Customer Notification

VR7701TM

64-bit Microprocessor

Operating Precautions

MMD(63:0), MMDP(7:0), MDQS(7:0) and MDQSP signal termination
(Specification change notice)

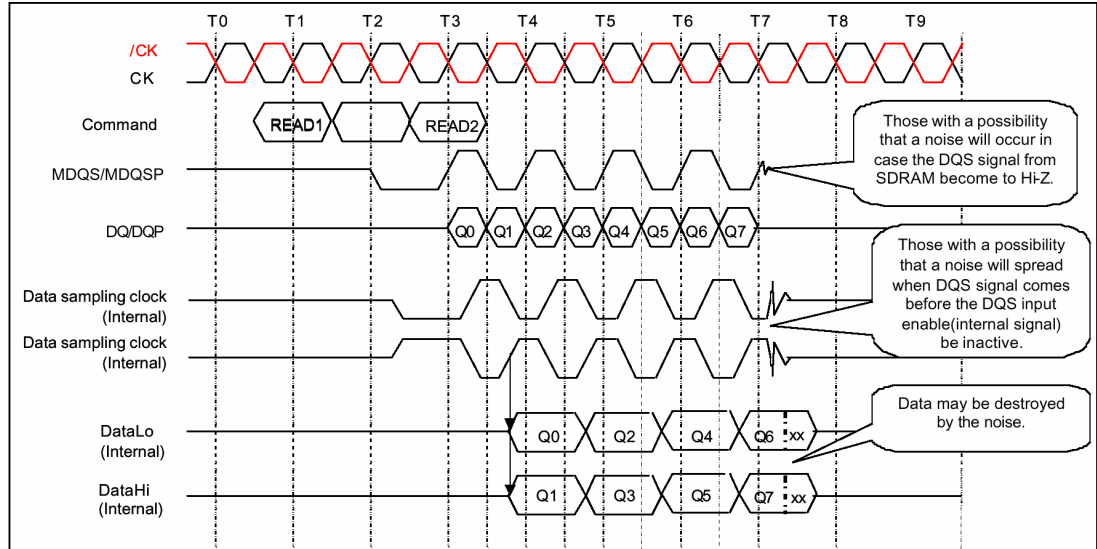
Noise on the MMD(63:0), MMDP(7:0), MDQS(7:0) and MDQSP pins may destroy memory read data as illustrated in below diagram.

To reduce the noise the following alternatives to standard termination of DDR-SDRAM data lines are recommended:
